RE: North River Gravel Pit Extension, Permit No. M-1999-007, Unresolved Problem(s) Noted in a Past Inspection Report

MINERALS PROGRAM INSPECTION REPORT
PHONE: (303) 866-3567

MINE NAME: North River Gravel Pit Extension	MINE/PROSPECTING ID#: M-1999-007	MINERAL: Gravel	COUNTY: Rio Blanco
INSPECTION TYPE: Surety Release Inspection	WEATHER: Clear	INSP. DATE: July 24, 2023	INSP. TIME: 12:30
OPERATOR: George T. Weldon Construction, LLC	OPERATOR REPRESENTATIVE: None	TYPE OF OPERATION: 110c - Construction Limited Impact	
REASON FOR INSPECTION: Surety Release Requested	BOND CALCULATION TYPE: None	BOND AMOUNT: \$11,750.00	
DATE OF COMPLAINT: NA	POST INSP. CONTACTS: None	JOINT INSP. AGENCY: None	
INSPECTOR(S): Amy Yeldell	INSPECTOR'S SIGNATURE: 	SIGNATURE DATE: August 10, 2023

Photo 2: Access road to Area 2 and 3

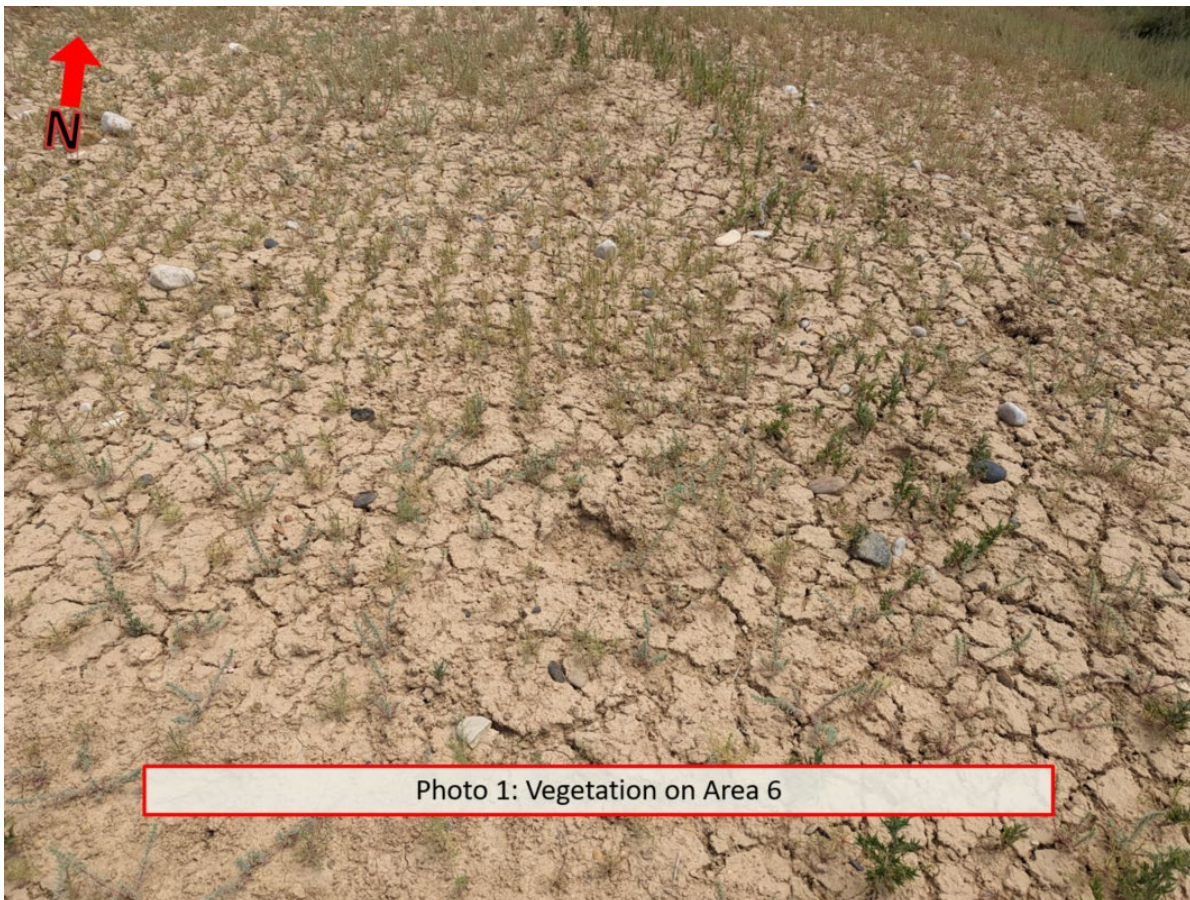
The access road to area 2 and 3 remains flat for future use but overall is well vegetated. Species are diverse and

generally weed free with some Kochia (See Photo Two). Little to no erosion was observed. Cover/density is comparable to undisturbed adjacent areas. It is noted on the northeast side of Area A adjacent to the access road several tires and other trash from historical use was observed.

Photo 3: Area A looking towards new reclaimed areas

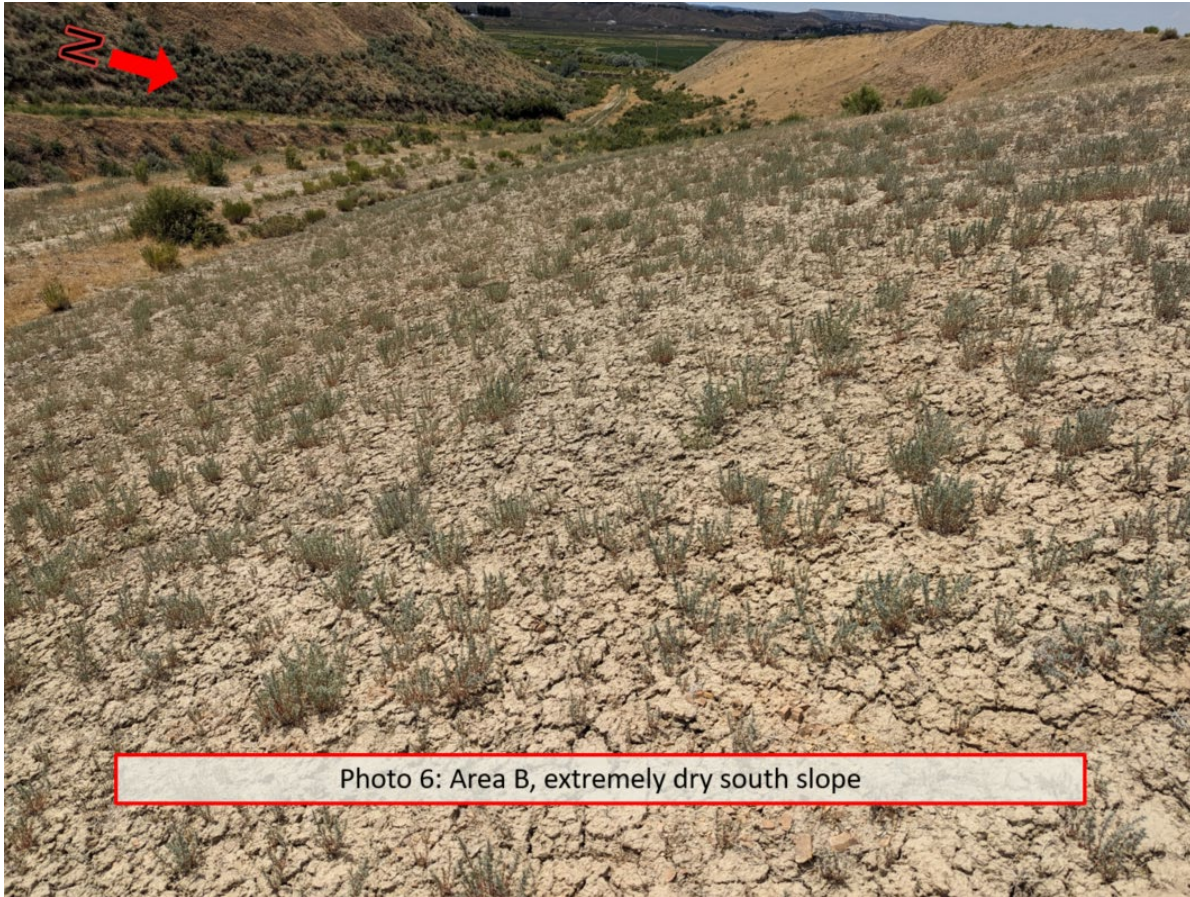
Area A did not require any sort of grading for final reclamation and has had volunteer shrubs (rabbit brush and saltbush) due to it being deserted. Only the southwestern portion of Areas A appear to have additional seeding. Cover is comprised of mostly desirable forbs (annual flowers) and shrubs. The recently reclaimed southwestern area has a lower density of desirable cover (See Photo Three). The rocky more open areas have significantly higher densities of cheatgrass and Russian Thistle.

Photo 9: Cracks in Area 4.

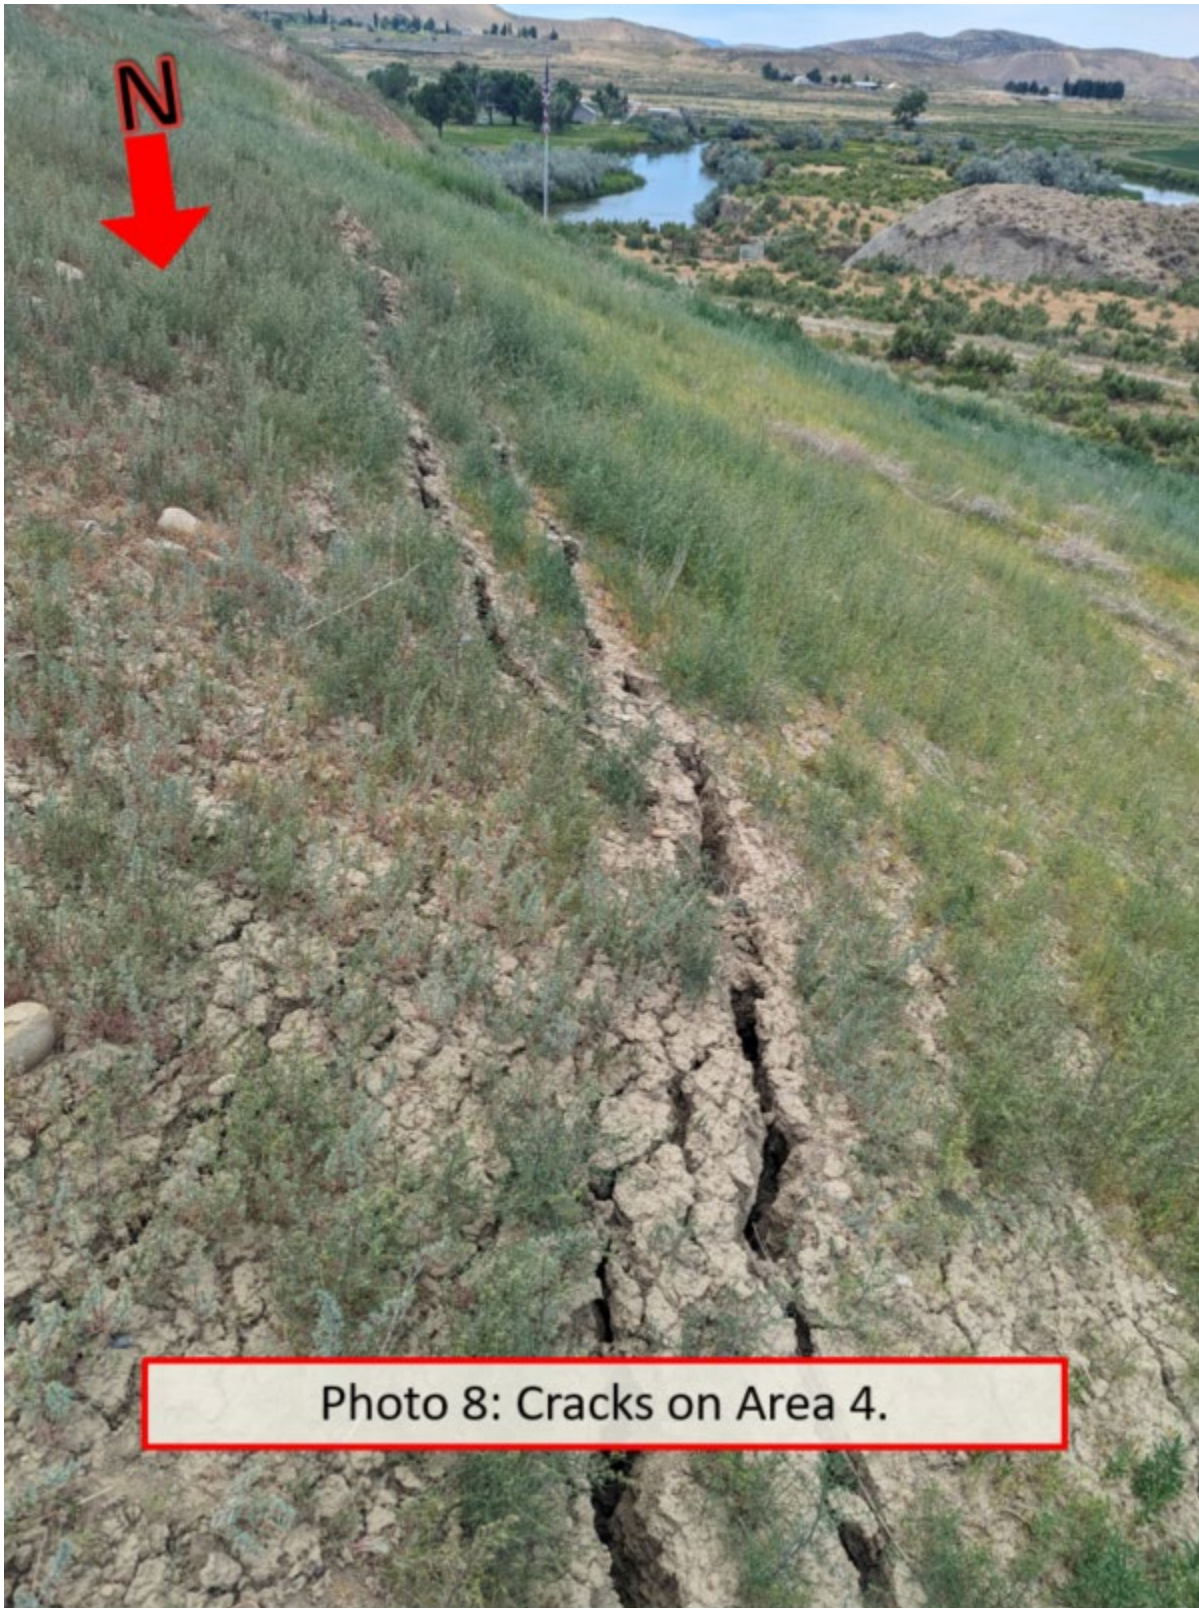
The western slope of area 4 has a stress crack (See Photo Eight and Nine). This slope will need to be repaired (graded) and reseeded. Given that sufficient material is on site a more gradual slope that is sufficiently compacted may resist settling better. The interstitial grade adjacent to the crack appears to be steeper than a 3H: 1V though the overall grade is a 3H: 1V. The crack is perpendicular to the slope and runs nearly the entire length of the slope. Smaller less apparent cracks were observed below the main one. This area will need to be repaired and reseeded.
